CITY OF HOOD RIVER

MEMORANDUM

To: City of Hood River Planning Commission
From: Jennifer Kaden, Associate Planner
Date: July 9, 2020
RE: Appeal of File No. 2020-07; Irving THmP

To: Bill Irving, Owner & Applicant
From: Jennifer Kaden, Associate Planner
Re: File No. 2020-07 – Minor Partition for a Townhouse Project

Examples of projections in Hood River

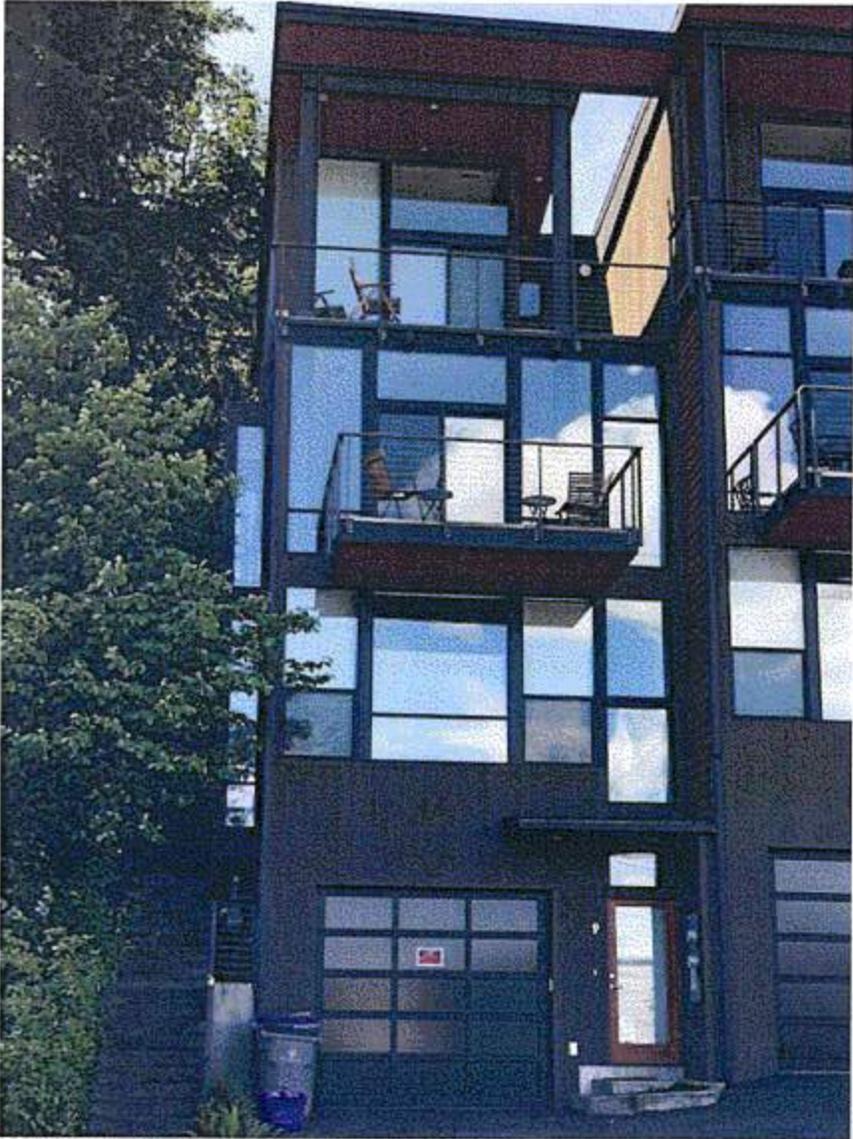
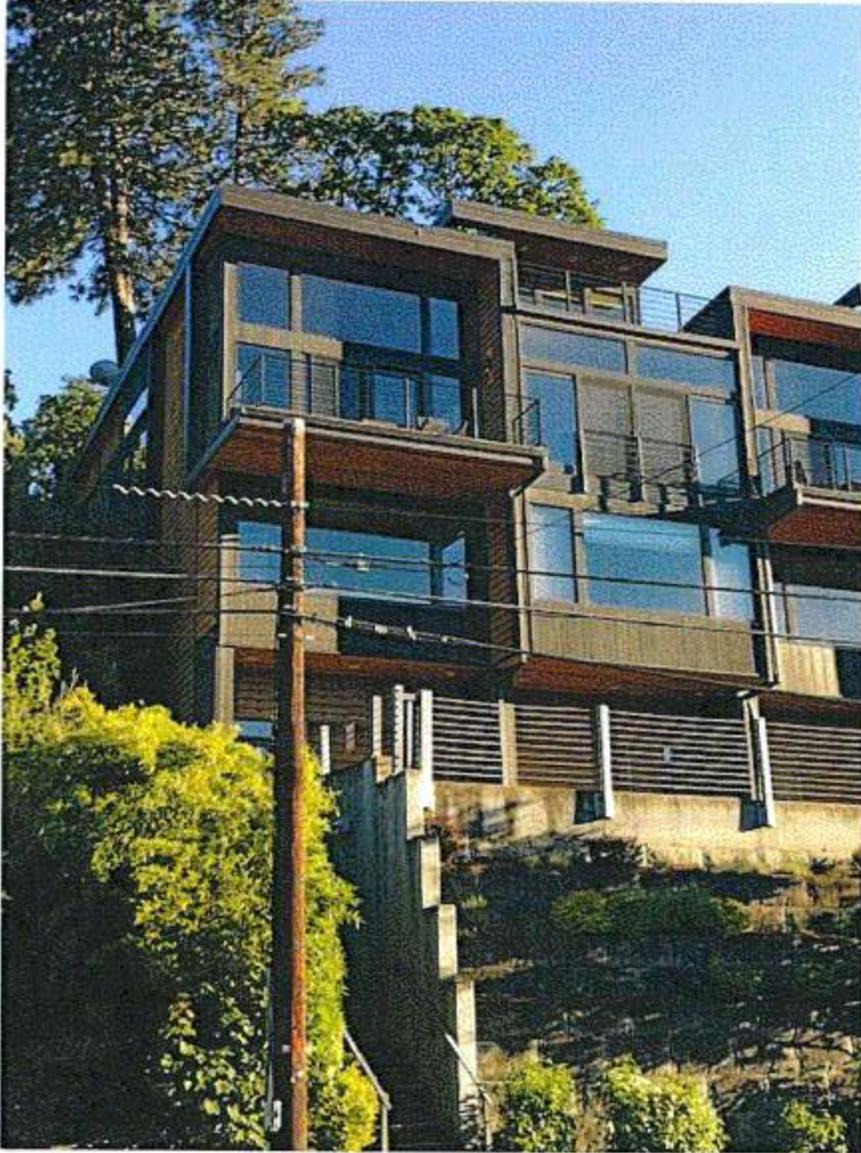
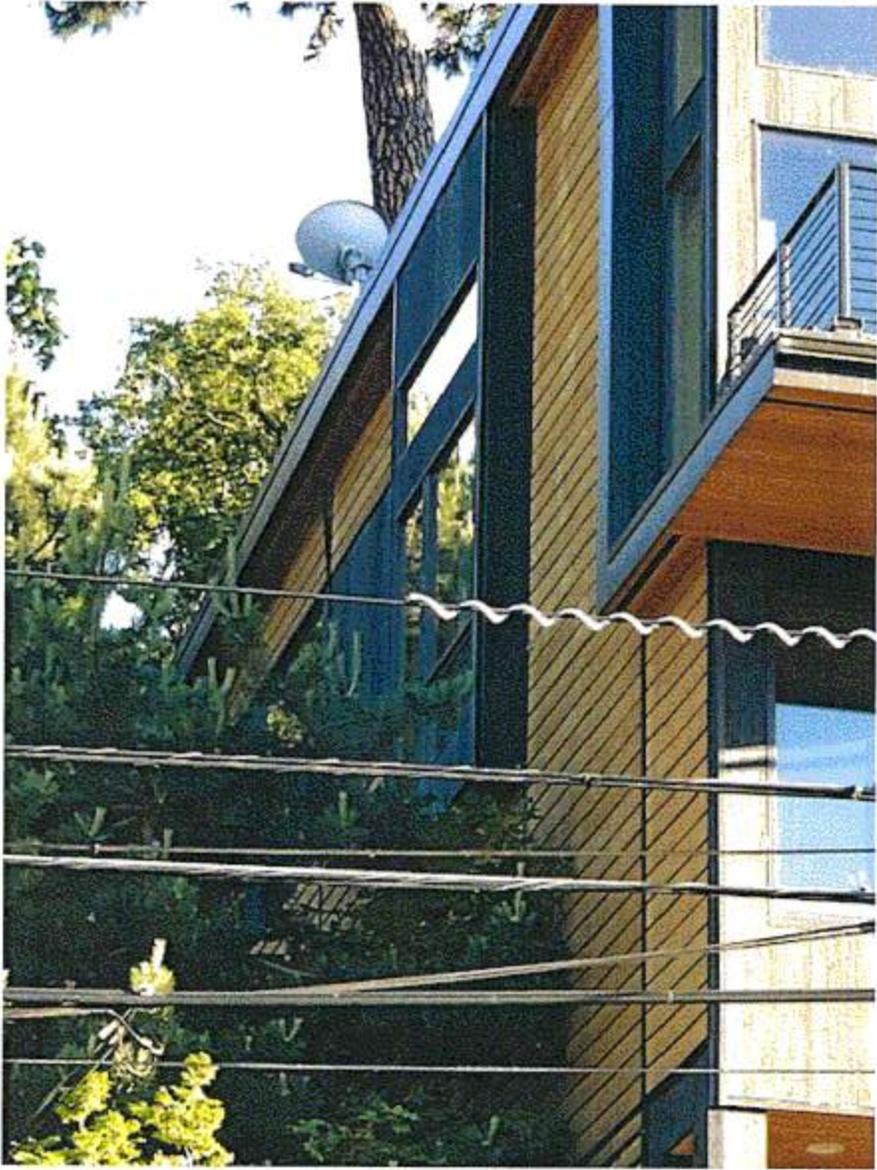
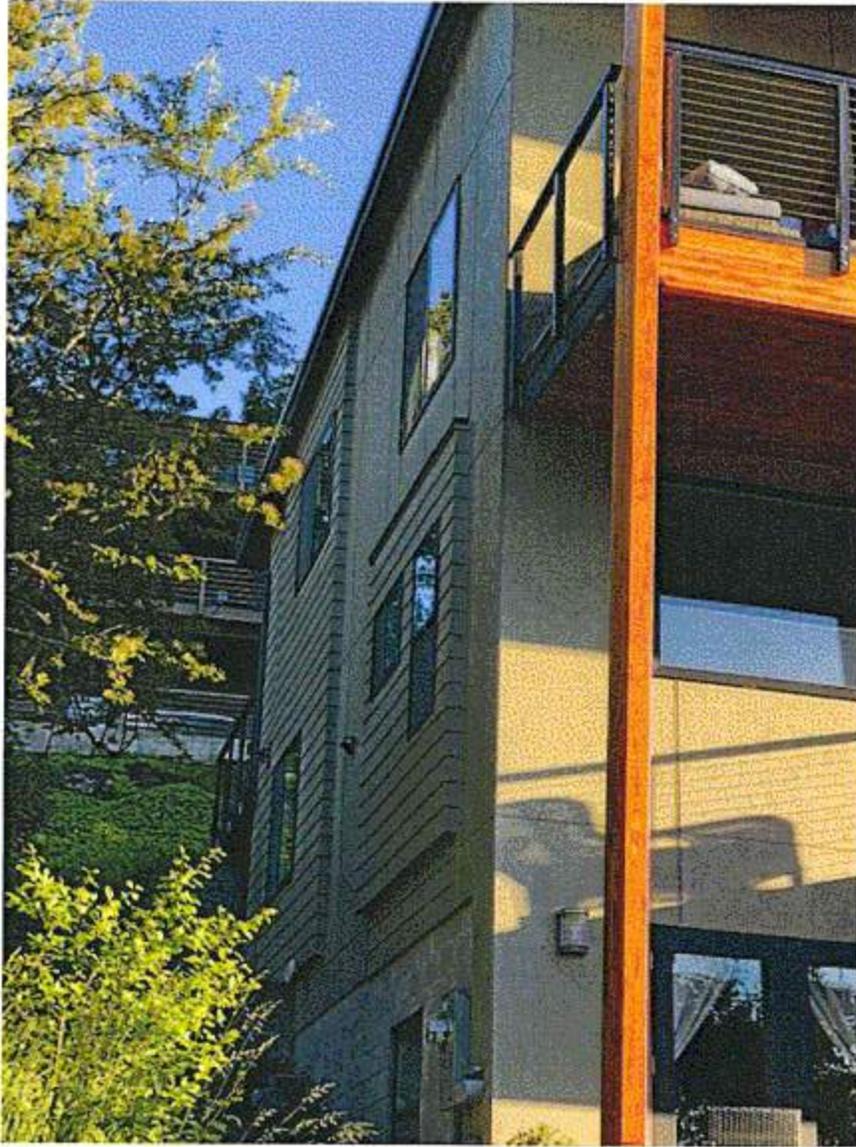
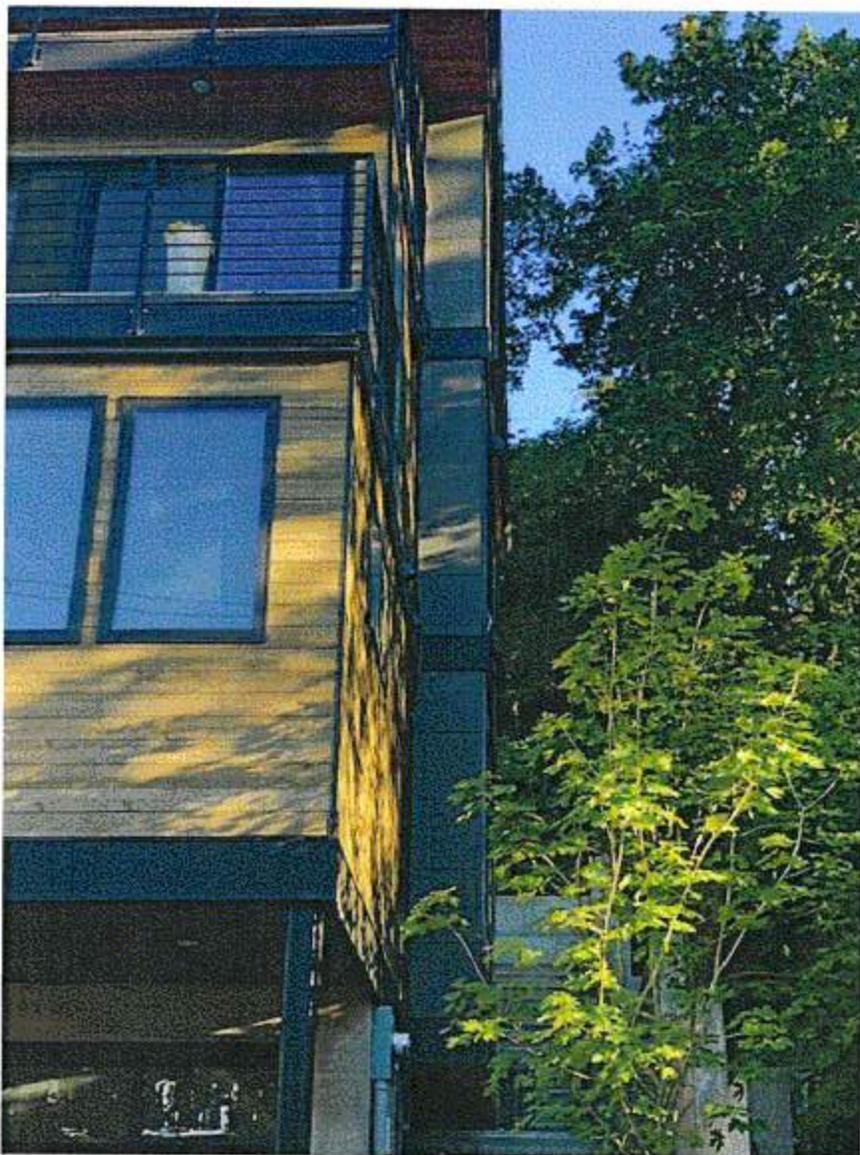
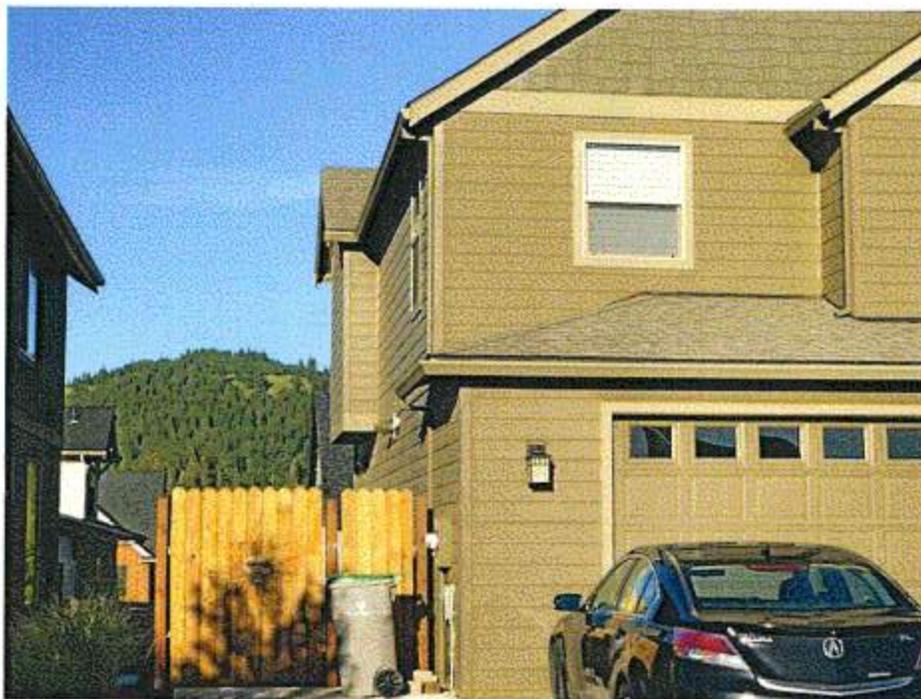
Within the city, there is significant historical precedent for using projections for form as well as function. There are examples from the modern era of development (subject to our current codeset) with mechanical chases, fireplaces, windows, and bump-outs as projections in the setback including a number of which have been vetted by the planning commission. In less than 20 mins of driving in two neighborhoods, I found more than 20 examples. I'll follow on this with photos.
